A Submission on the Sydney Light Rail Extension Stage 1– Inner West Extension Environmental Assessment

Prepared by: EcoTransit Sydney

Date: 12 November 2010

Application reference number: MP 10_0111

Illustration 3.1: Connecting the light and heavy rail networks at Lewisham

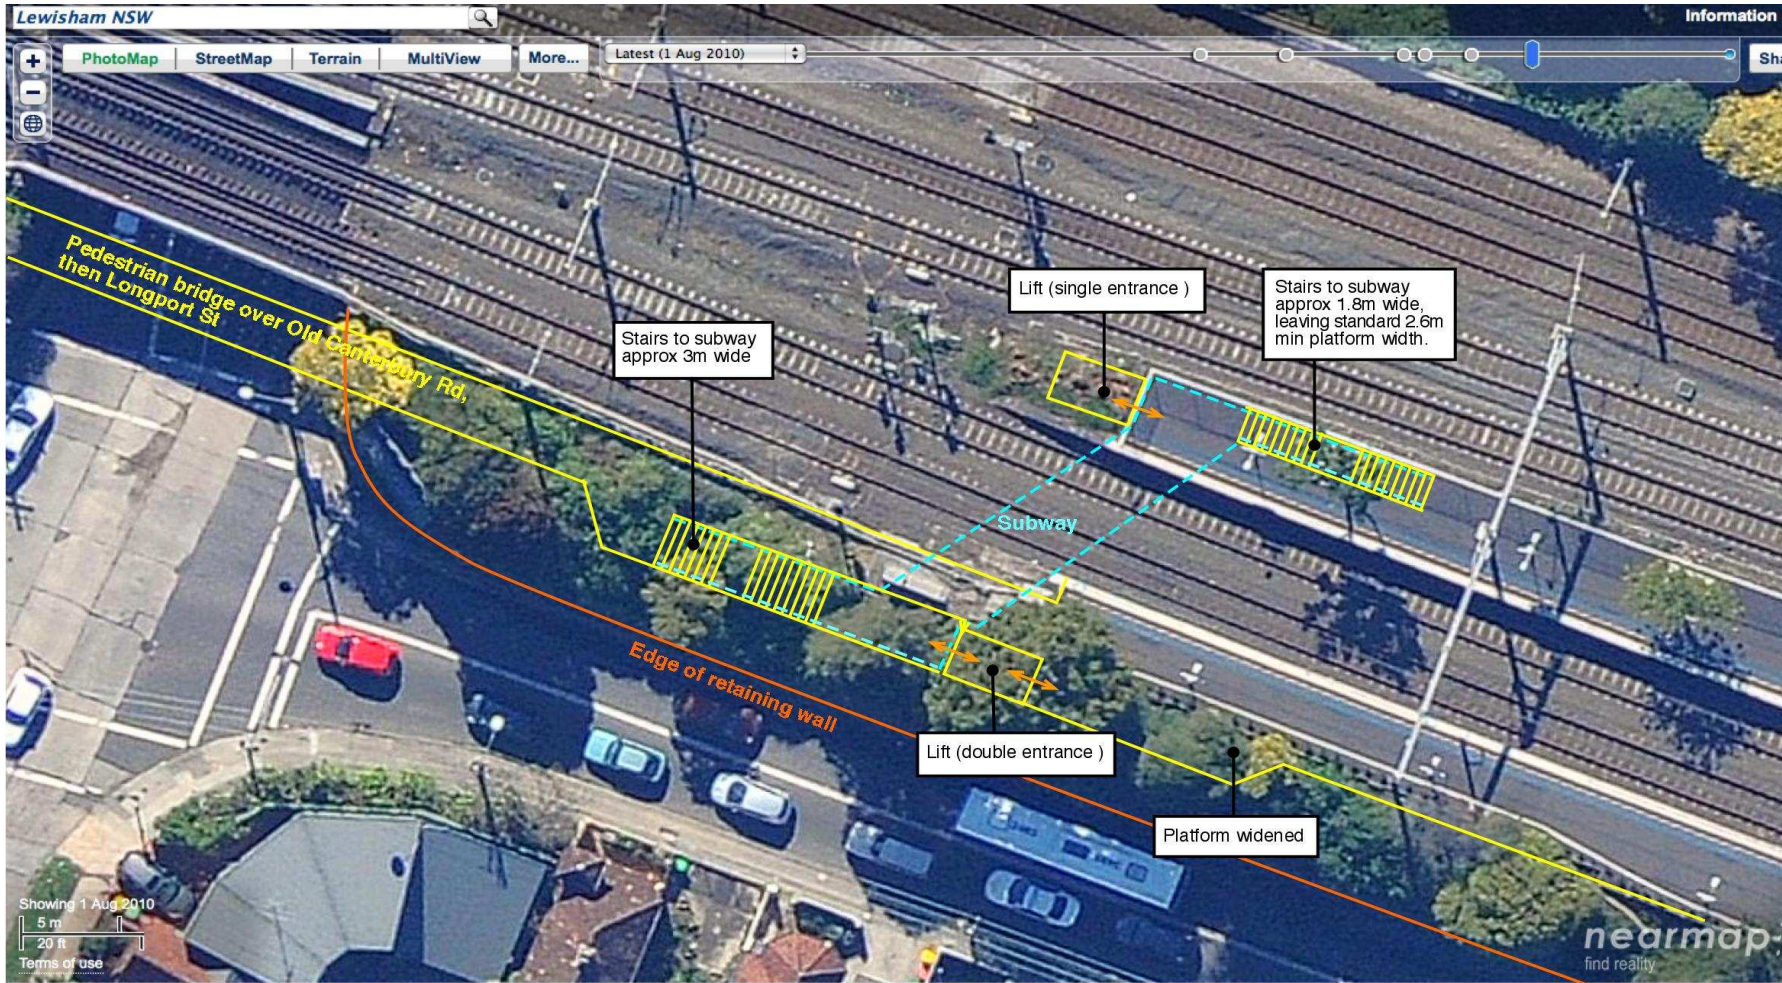
EcoTransit Sydney supports the proposal to locate the Lewisham West light rail stop between Longport Street and Old Canterbury Road. ***We would urge, however, that the stop be located so that it does not preclude the possibility of it serving as a viable transport interchange between the light rail and heavy rail networks. This is best achieved by locating the stop as far north (ie close to Longport Street) as possible.***

EcoTransit strongly recommends that the Lewisham West stop be moved further north to a position where it would provide the quickest, most convenient possible pedestrian link between the Lewisham West stop and Lewisham Station. This link is vital because it will enable light rail to act as a feeder to the Main Western line and as a convenient shortcut between the Bankstown and Main Western lines, thereby taking pressure off Redfern Station. Over time, and with the integration of light rail into the MyZone scheme, these functions will assume considerable importance.

In particular the pedestrian link must avoid at-grade road crossings since the surrounding roads are very busy. By locating the stop further north and applying the principles of Transit Oriented Development, an opportunity would exist for creating a shorter, more direct connection between the light rail stop and Lewisham Station.

The best, most direct route for this link is shown in Illustration 3.1. Passengers transferring from the light rail stop to Lewisham station would traverse the proposed retail precinct of the Lewisham Estate development. Passing through an active shopping precinct will offer an enhanced level of convenience and personal safety for passengers.

After exiting the shopping precinct, stairs and a lift would provide access to a bridge over Longport Street and then Old Canterbury Road before entering the west end of the westbound Lewisham platform. Direct access to the west end of the Lewisham Station should be supplemented by a subway connection (serviced by lifts) between the platforms at the west end of the station.

The resulting connection would be approximately 270m in length. This scheme would allow a stop to station transfer time of about 2 min. 30 secs, which is very reasonable. It compares with, say, walking from Platform 22 at Central to the Eddy Avenue bus rank or light rail stop, or transferring from the city to the country platforms.

Illustration 3.3: Light rail stop coverage

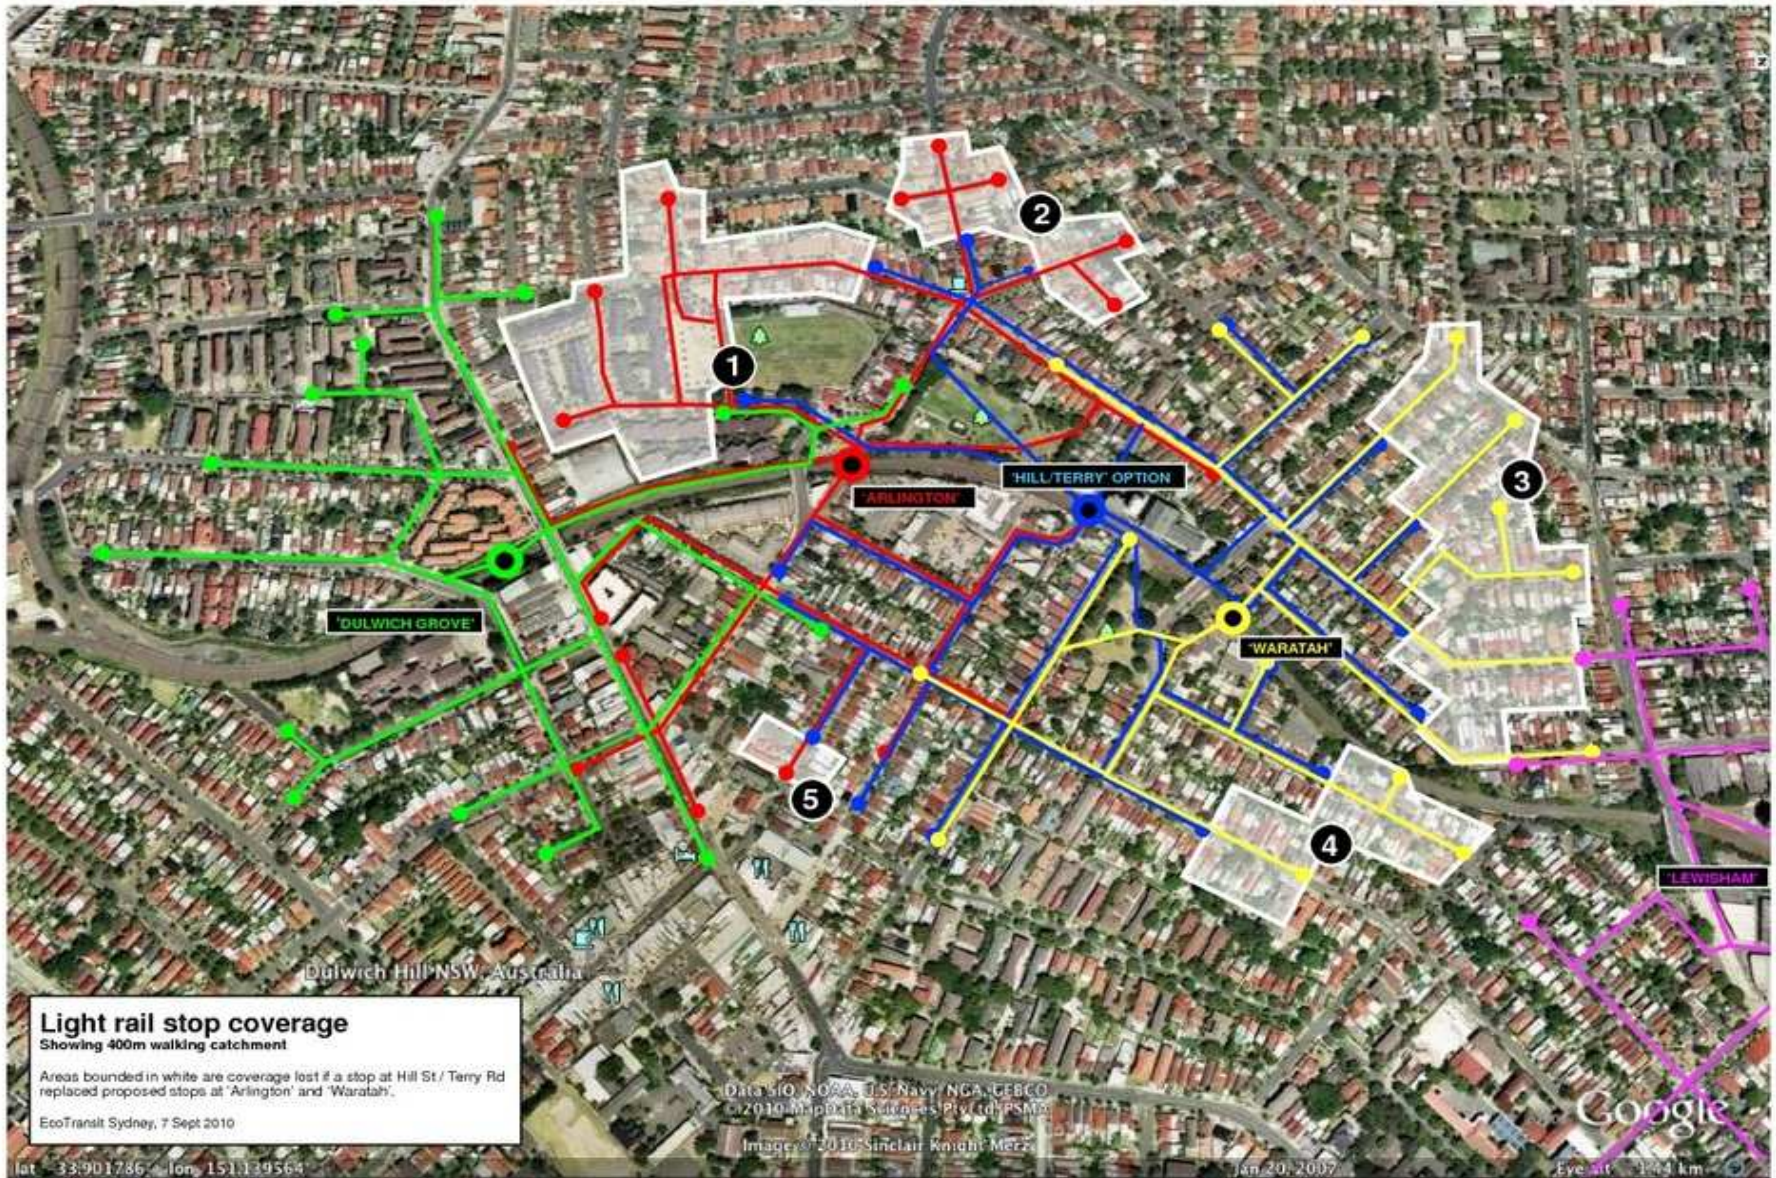
While not listed as an option in the Environmental Assessment, EcoTransit Sydney would like to take this opportunity to express its strong support for the retention of the Waratah and Arlington stops and its objection to the proposal that they be replaced by a single stop at Hill St/Terry Rd.

The primary basis of the objection to the single Hill St/Terry Rd stop would be the negative impact it would have on patronage and accessibility. One can compare the number of properties that fall within the 400m walking catchment of each stop, as shown in Illustration 3.3.

Those areas marked in white indicate the properties that would fall outside the 400m patronage catchment as a consequence of substituting the Hill St/Terry Rd stop for the Waratah and Arlington stops. These areas include several medium density developments, and given typical occupancy rates, correspond to 1200 residents.
